**To:** Bassett Creek Watershed Management Commission (BCWMC)  
**From:** Barr Engineering Co. (Barr)  
**Subject:** Item 4D: Bassett Creek Park Pedestrian Bridge Improvement – Crystal, MN  
BCWMC October 20, 2022 Meeting Agenda  
**Date:** October 13, 2022  
**Project:** 23270051.53 2022 2287

### 4D Bassett Creek Park Pedestrian Bridge Improvement–Crystal, MN BCWMC 2022-08

**Figure 1: Model Extents in HEC-RAS**

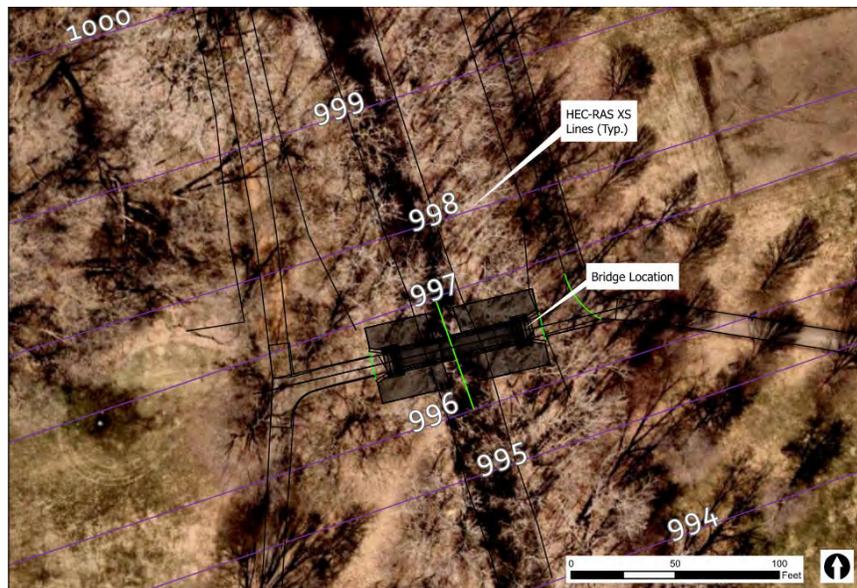
A HEC-RAS model was developed to model the existing and proposed condition to demonstrate no rise in flood level along the creek. The HEC-RAS model was used to perform a relative comparison of the existing bridge and the new bridge at this location.

Information used to create the HEC-RAS model included flow data and boundary conditions from the BCWMC XP-SWMM model, topography data from the MDNR, and survey data collected as part of the proposed project. The HEC-RAS model included roughly 320 feet of Bassett Creek north of Bassett Creek Park Pond. Approximately 190 feet of channel upstream of the pedestrian bridge was modeled, and 130 feet of the downstream channel was modeled. The applicant developed 8 cross-sections along this reach to define the channel and/or bridge geometry that was used to calculate the water surface level. Figure 1 shows the cross-section locations.

Table 1 reports the 100-year high water elevation for all eight cross sections for the existing conditions (existing bridge) and proposed conditions (new bridge). Results shown in Table 1 demonstrate “no increase in flood level” when comparing the existing and proposed bridge.
